FOUNDATION | CULTURAL CAMPUS 53 FIRST STREET, HUDSON, OHIO 44236

Re: Peg's Foundation Cultural Campus – 53 First Street

Preliminary Engineering Approval- Viewpoint #21-1046

**SUBJECT:** Peg's Foundation Cultural Campus - 53 First Street

C-102

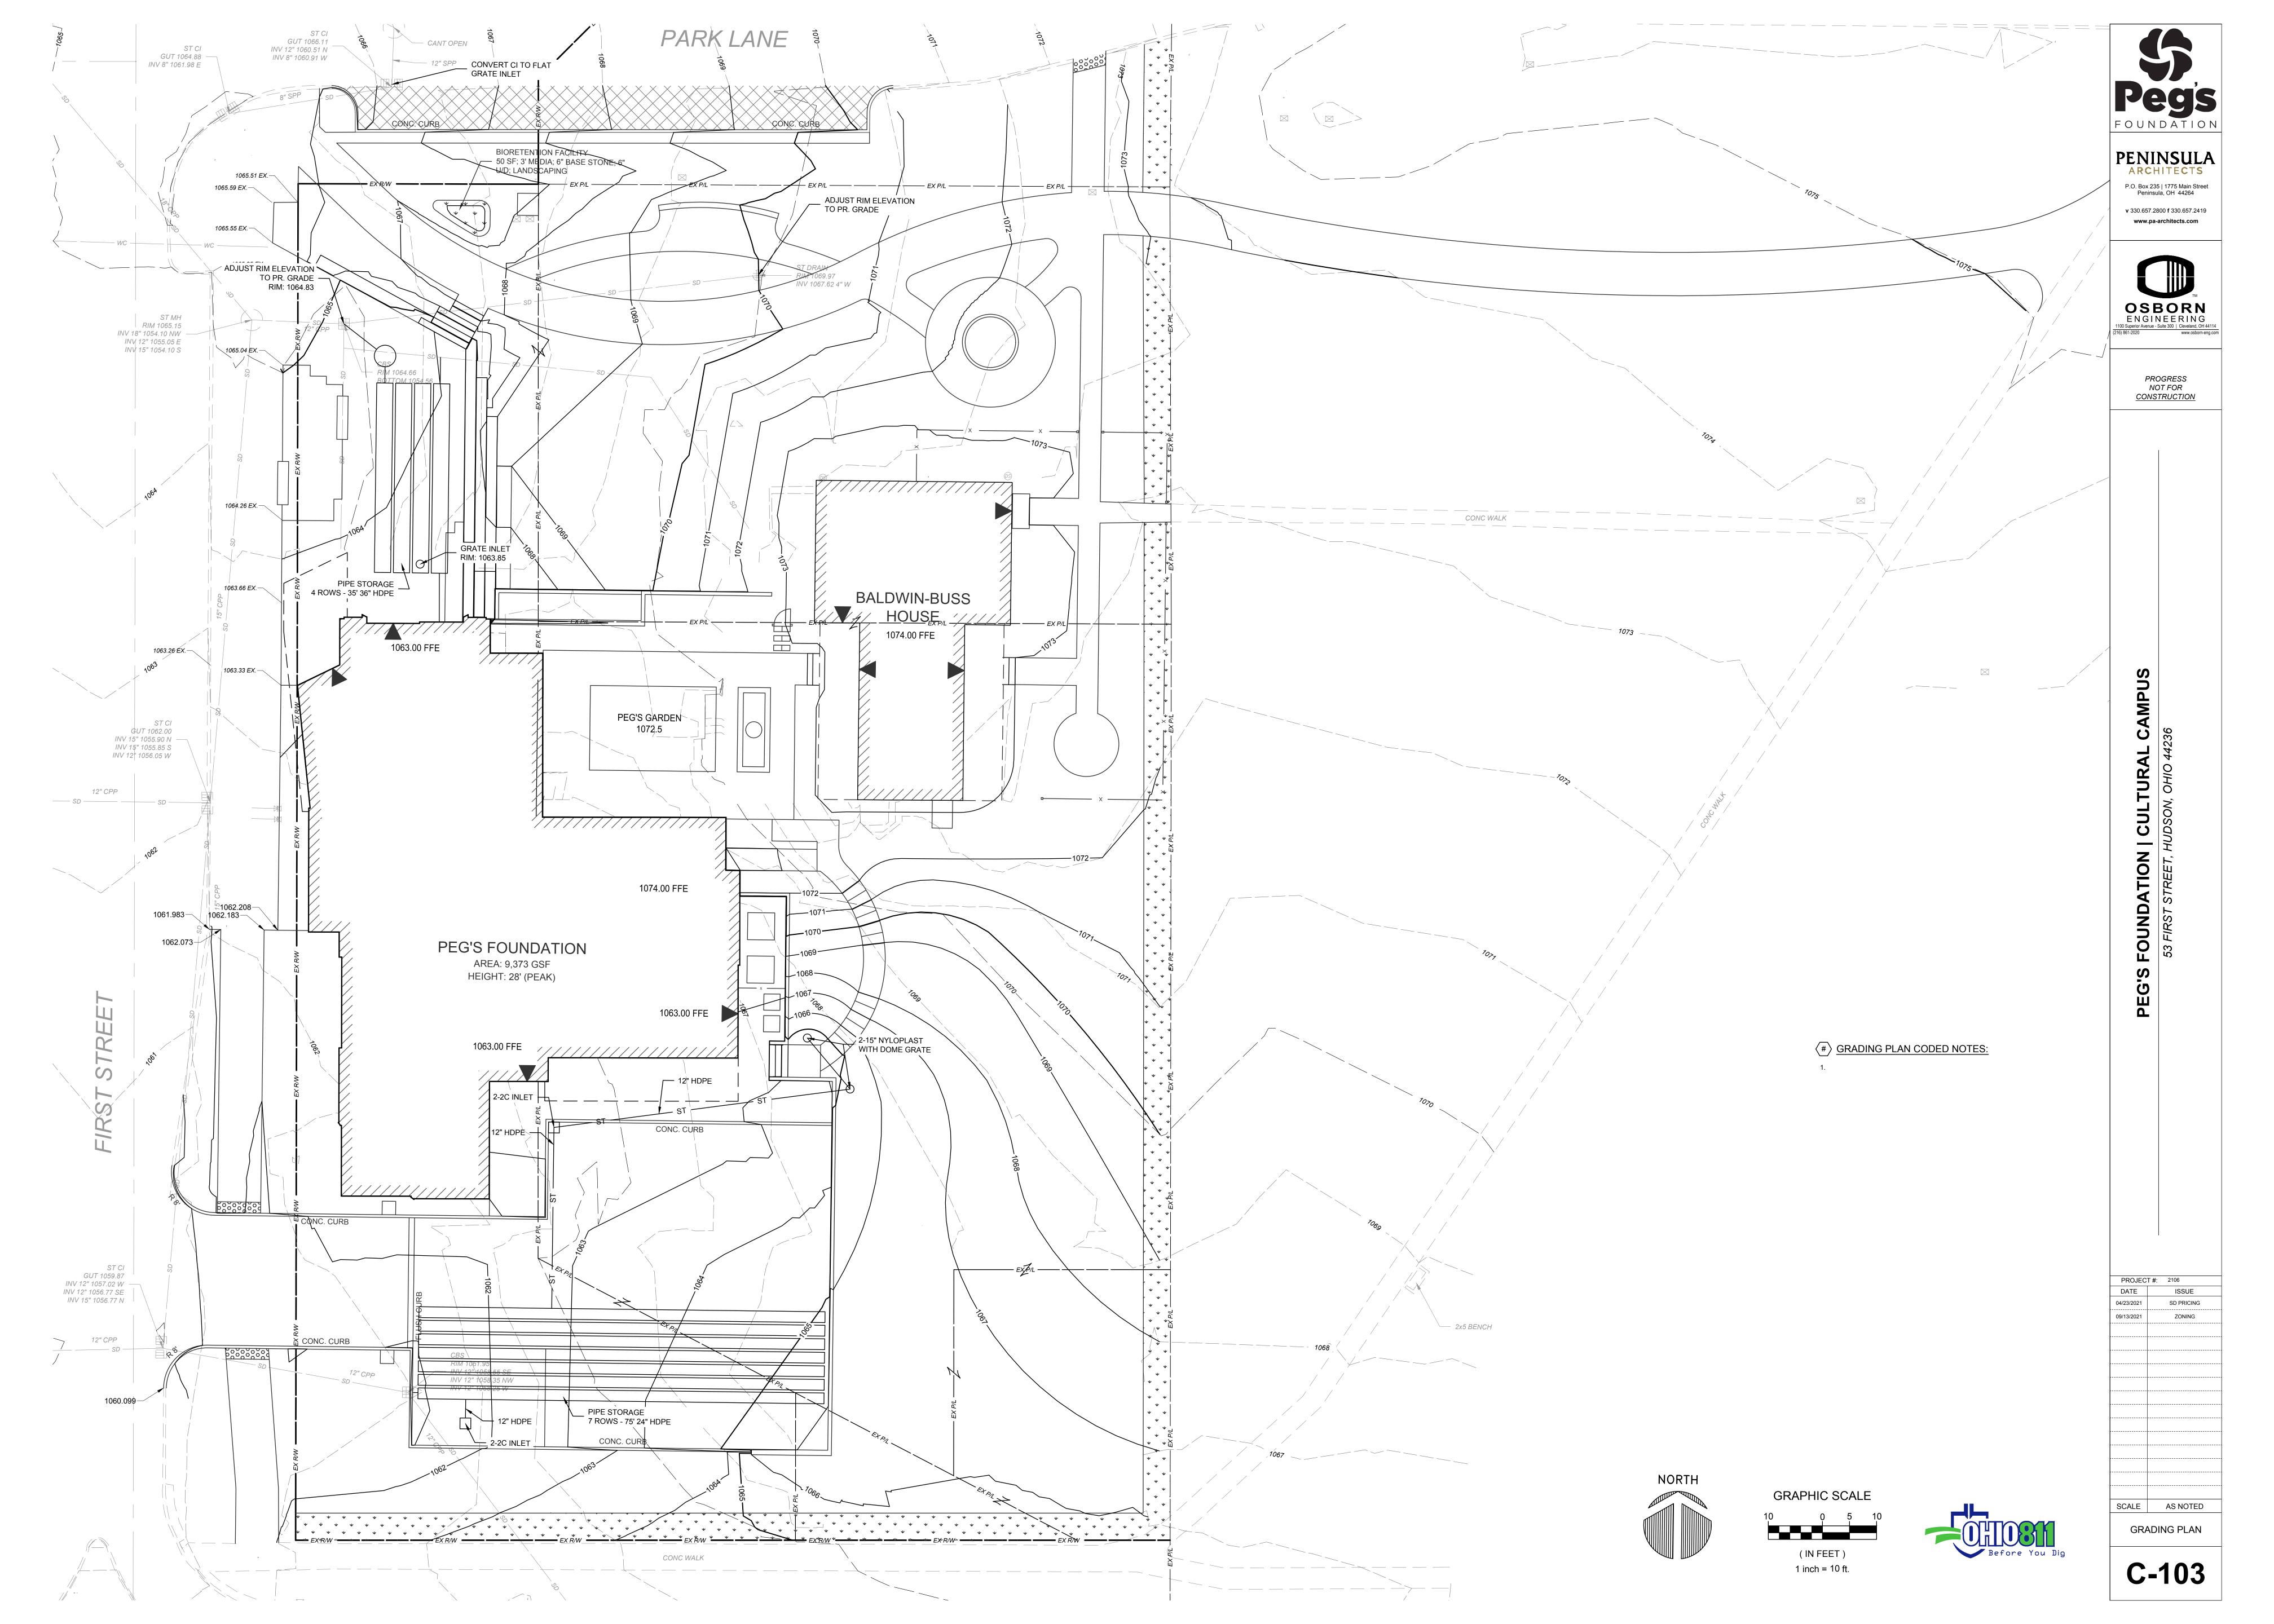
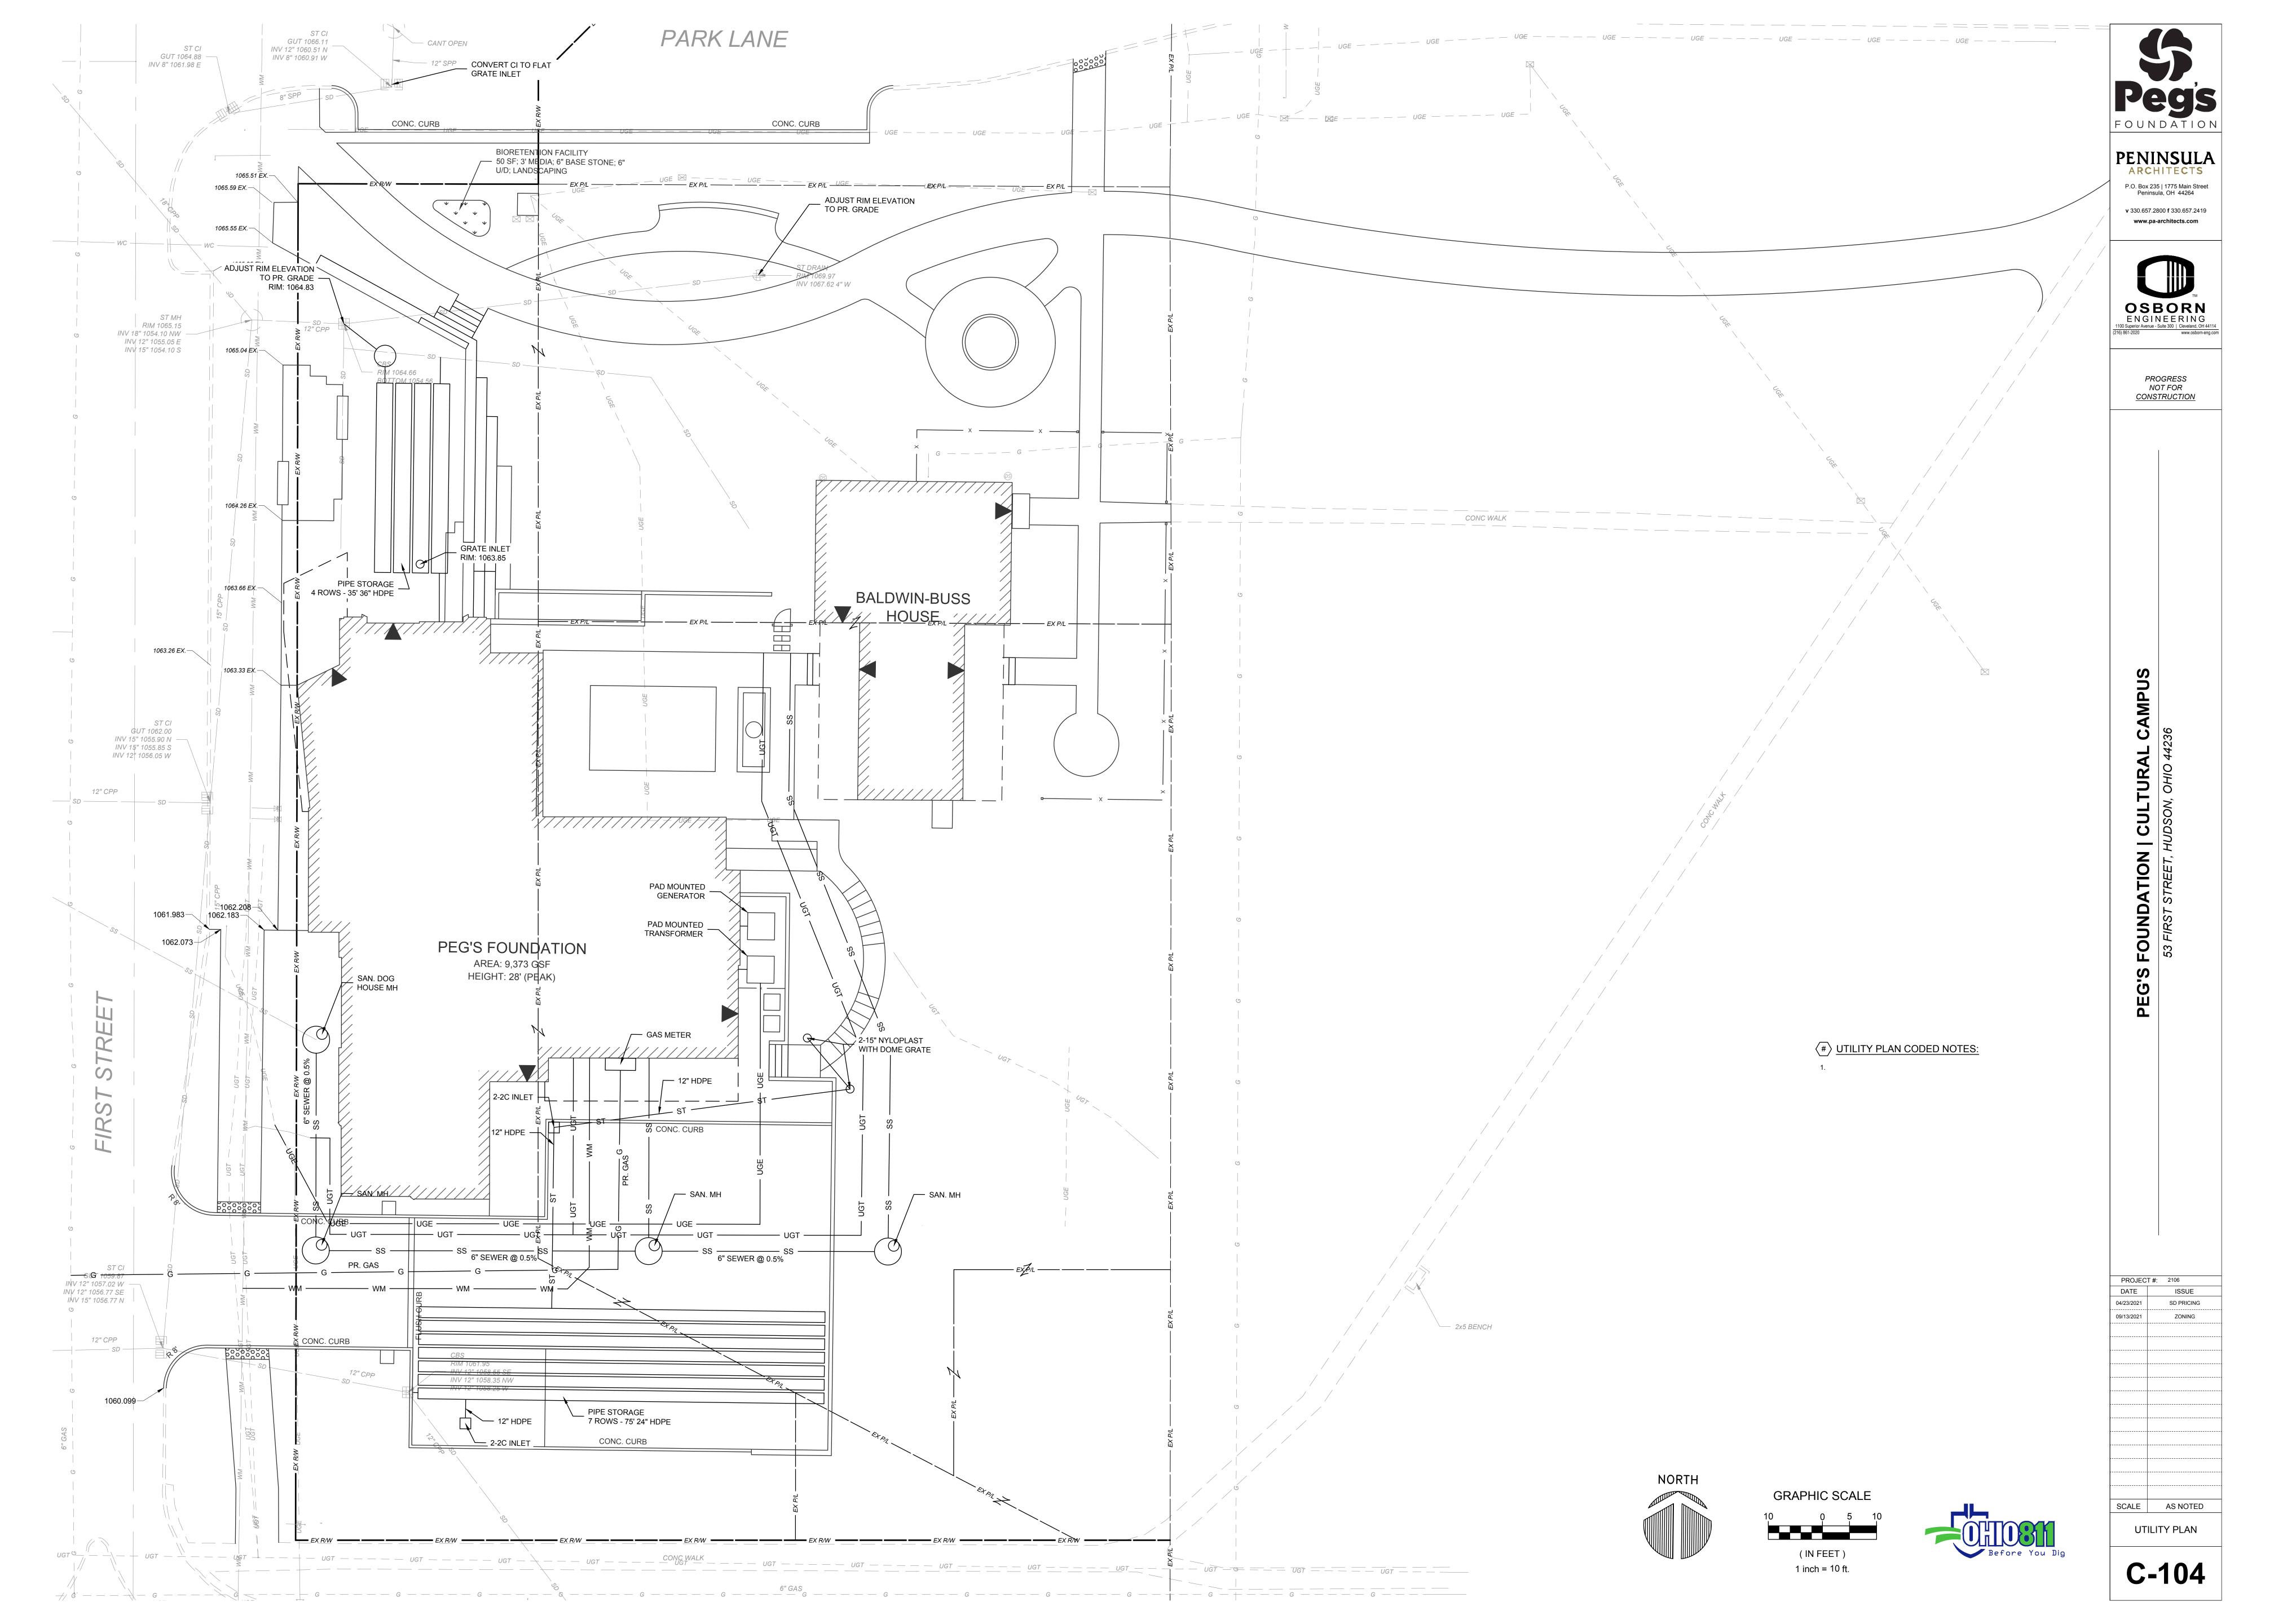
- 6. Provide the pre and post impervious surface area on the title sheet per Hudson Engineering Standards Section 1.7. Also indicate the total area of disturbance for the project.
